<b>B 1</b>	SEQUENCE NO. (MDE USE ONLY) <b>005274</b>	STATE OF MARYLAND <b>APPLICATION FOR PERMIT TO DRILL WELL</b> please type <b>590374</b>	STATE PERMIT NUMBER <b>H0-25-0086</b> <small>70 fill in this form completely 79</small>
------------	--	--	---

3534 Church Rd  
Ellicott City Md  
2 wells @ 240' each  
closed loop geothermal

**From:** Page, Shepsura  
**Sent:** Tuesday, March 31, 2026 2:13 PM  
**To:** 'Wes Wolfe'  
**Cc:** 'Donna Perez'; Wolf, Kevin  
**Subject:** RE: 3534 Church Rd- Geo-Well Application Status

### SITE PLAN

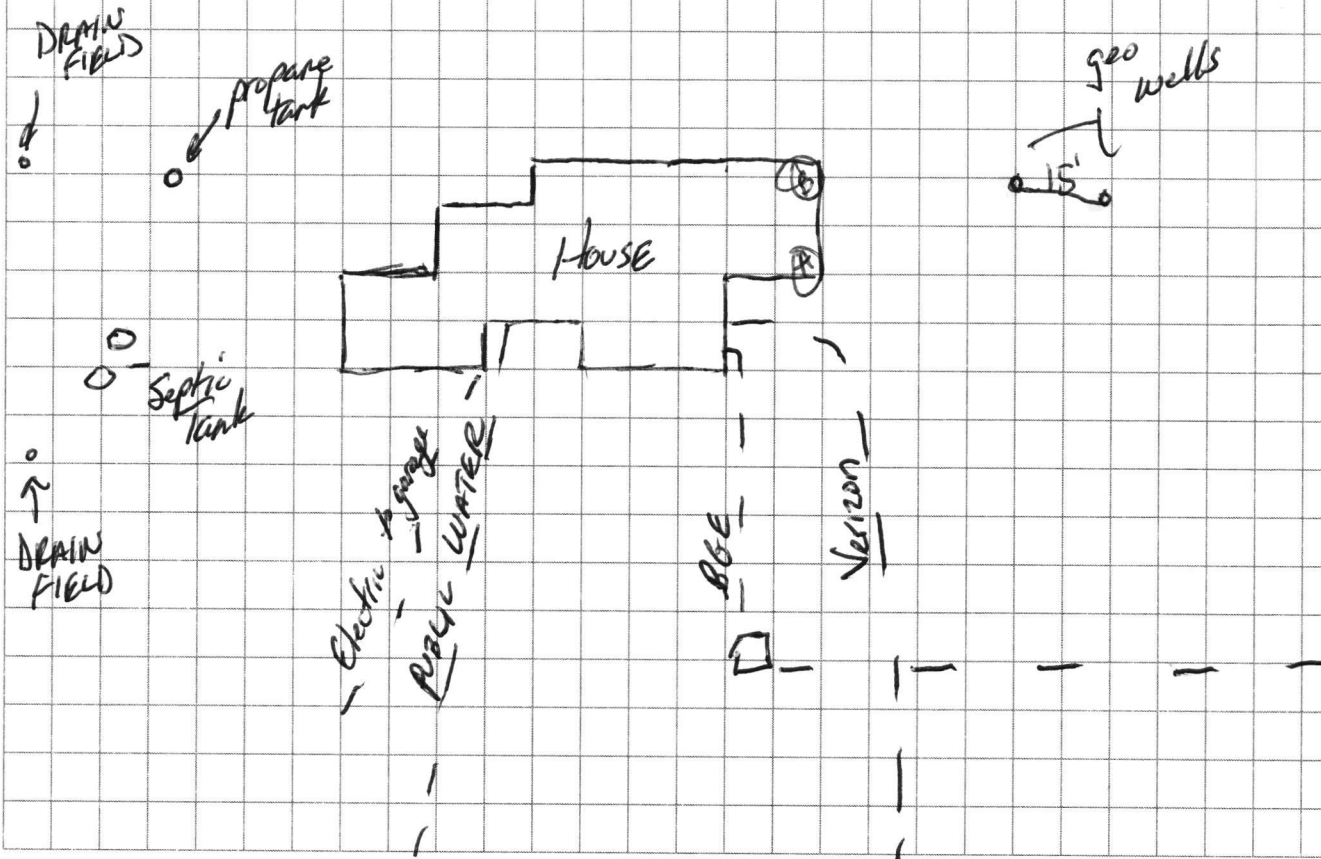
Thanks Wes, this helps a lot. I see the perc tests on the plan but could you include the septic tank and drain field as well? Sorry should've asked for that initially.

Pardon the delay in responding. I have not been to the site yet but I understand what you're stating. Would you be able to show the site plan on the as built plat for the property? That would give a better visual of where the proposed wells are in comparison to setbacks.

Thanks Wes, do you have the actual distance to the water line? If not and it's marked, I can put the measurement on the plan with your permission.

Is this the closest property line? Can you draw where it's located on the site plan (see attached)?

What is the distance between the public water line and geo-well, is the water line marked?

Wes, site conditions match your plan and meet setbacks. The permit has been approved. Would you like to receive the permit via mail or pick up?

Yeah as I said everything is visible on site we are nowhere near anything. The property is huge. Have you done the site inspection? Let me know when this ready to pick up or if you need meet someone on-site. The owner is very anxious to get this done

I don't have the exact measurements to place them on the plan. They are on my site drawing and we are well over 100 feet away. I ran out of tape on my 100' tape. They are all visible on site

It's well over 50'; I'm on the adjacent side. This is a big property. Have you been there yet?

Attached is the as built plat for the property. It shows the water line. There are no property lines close enough to measure due to the slopes. Let me know if this helps you out. It's a large property.
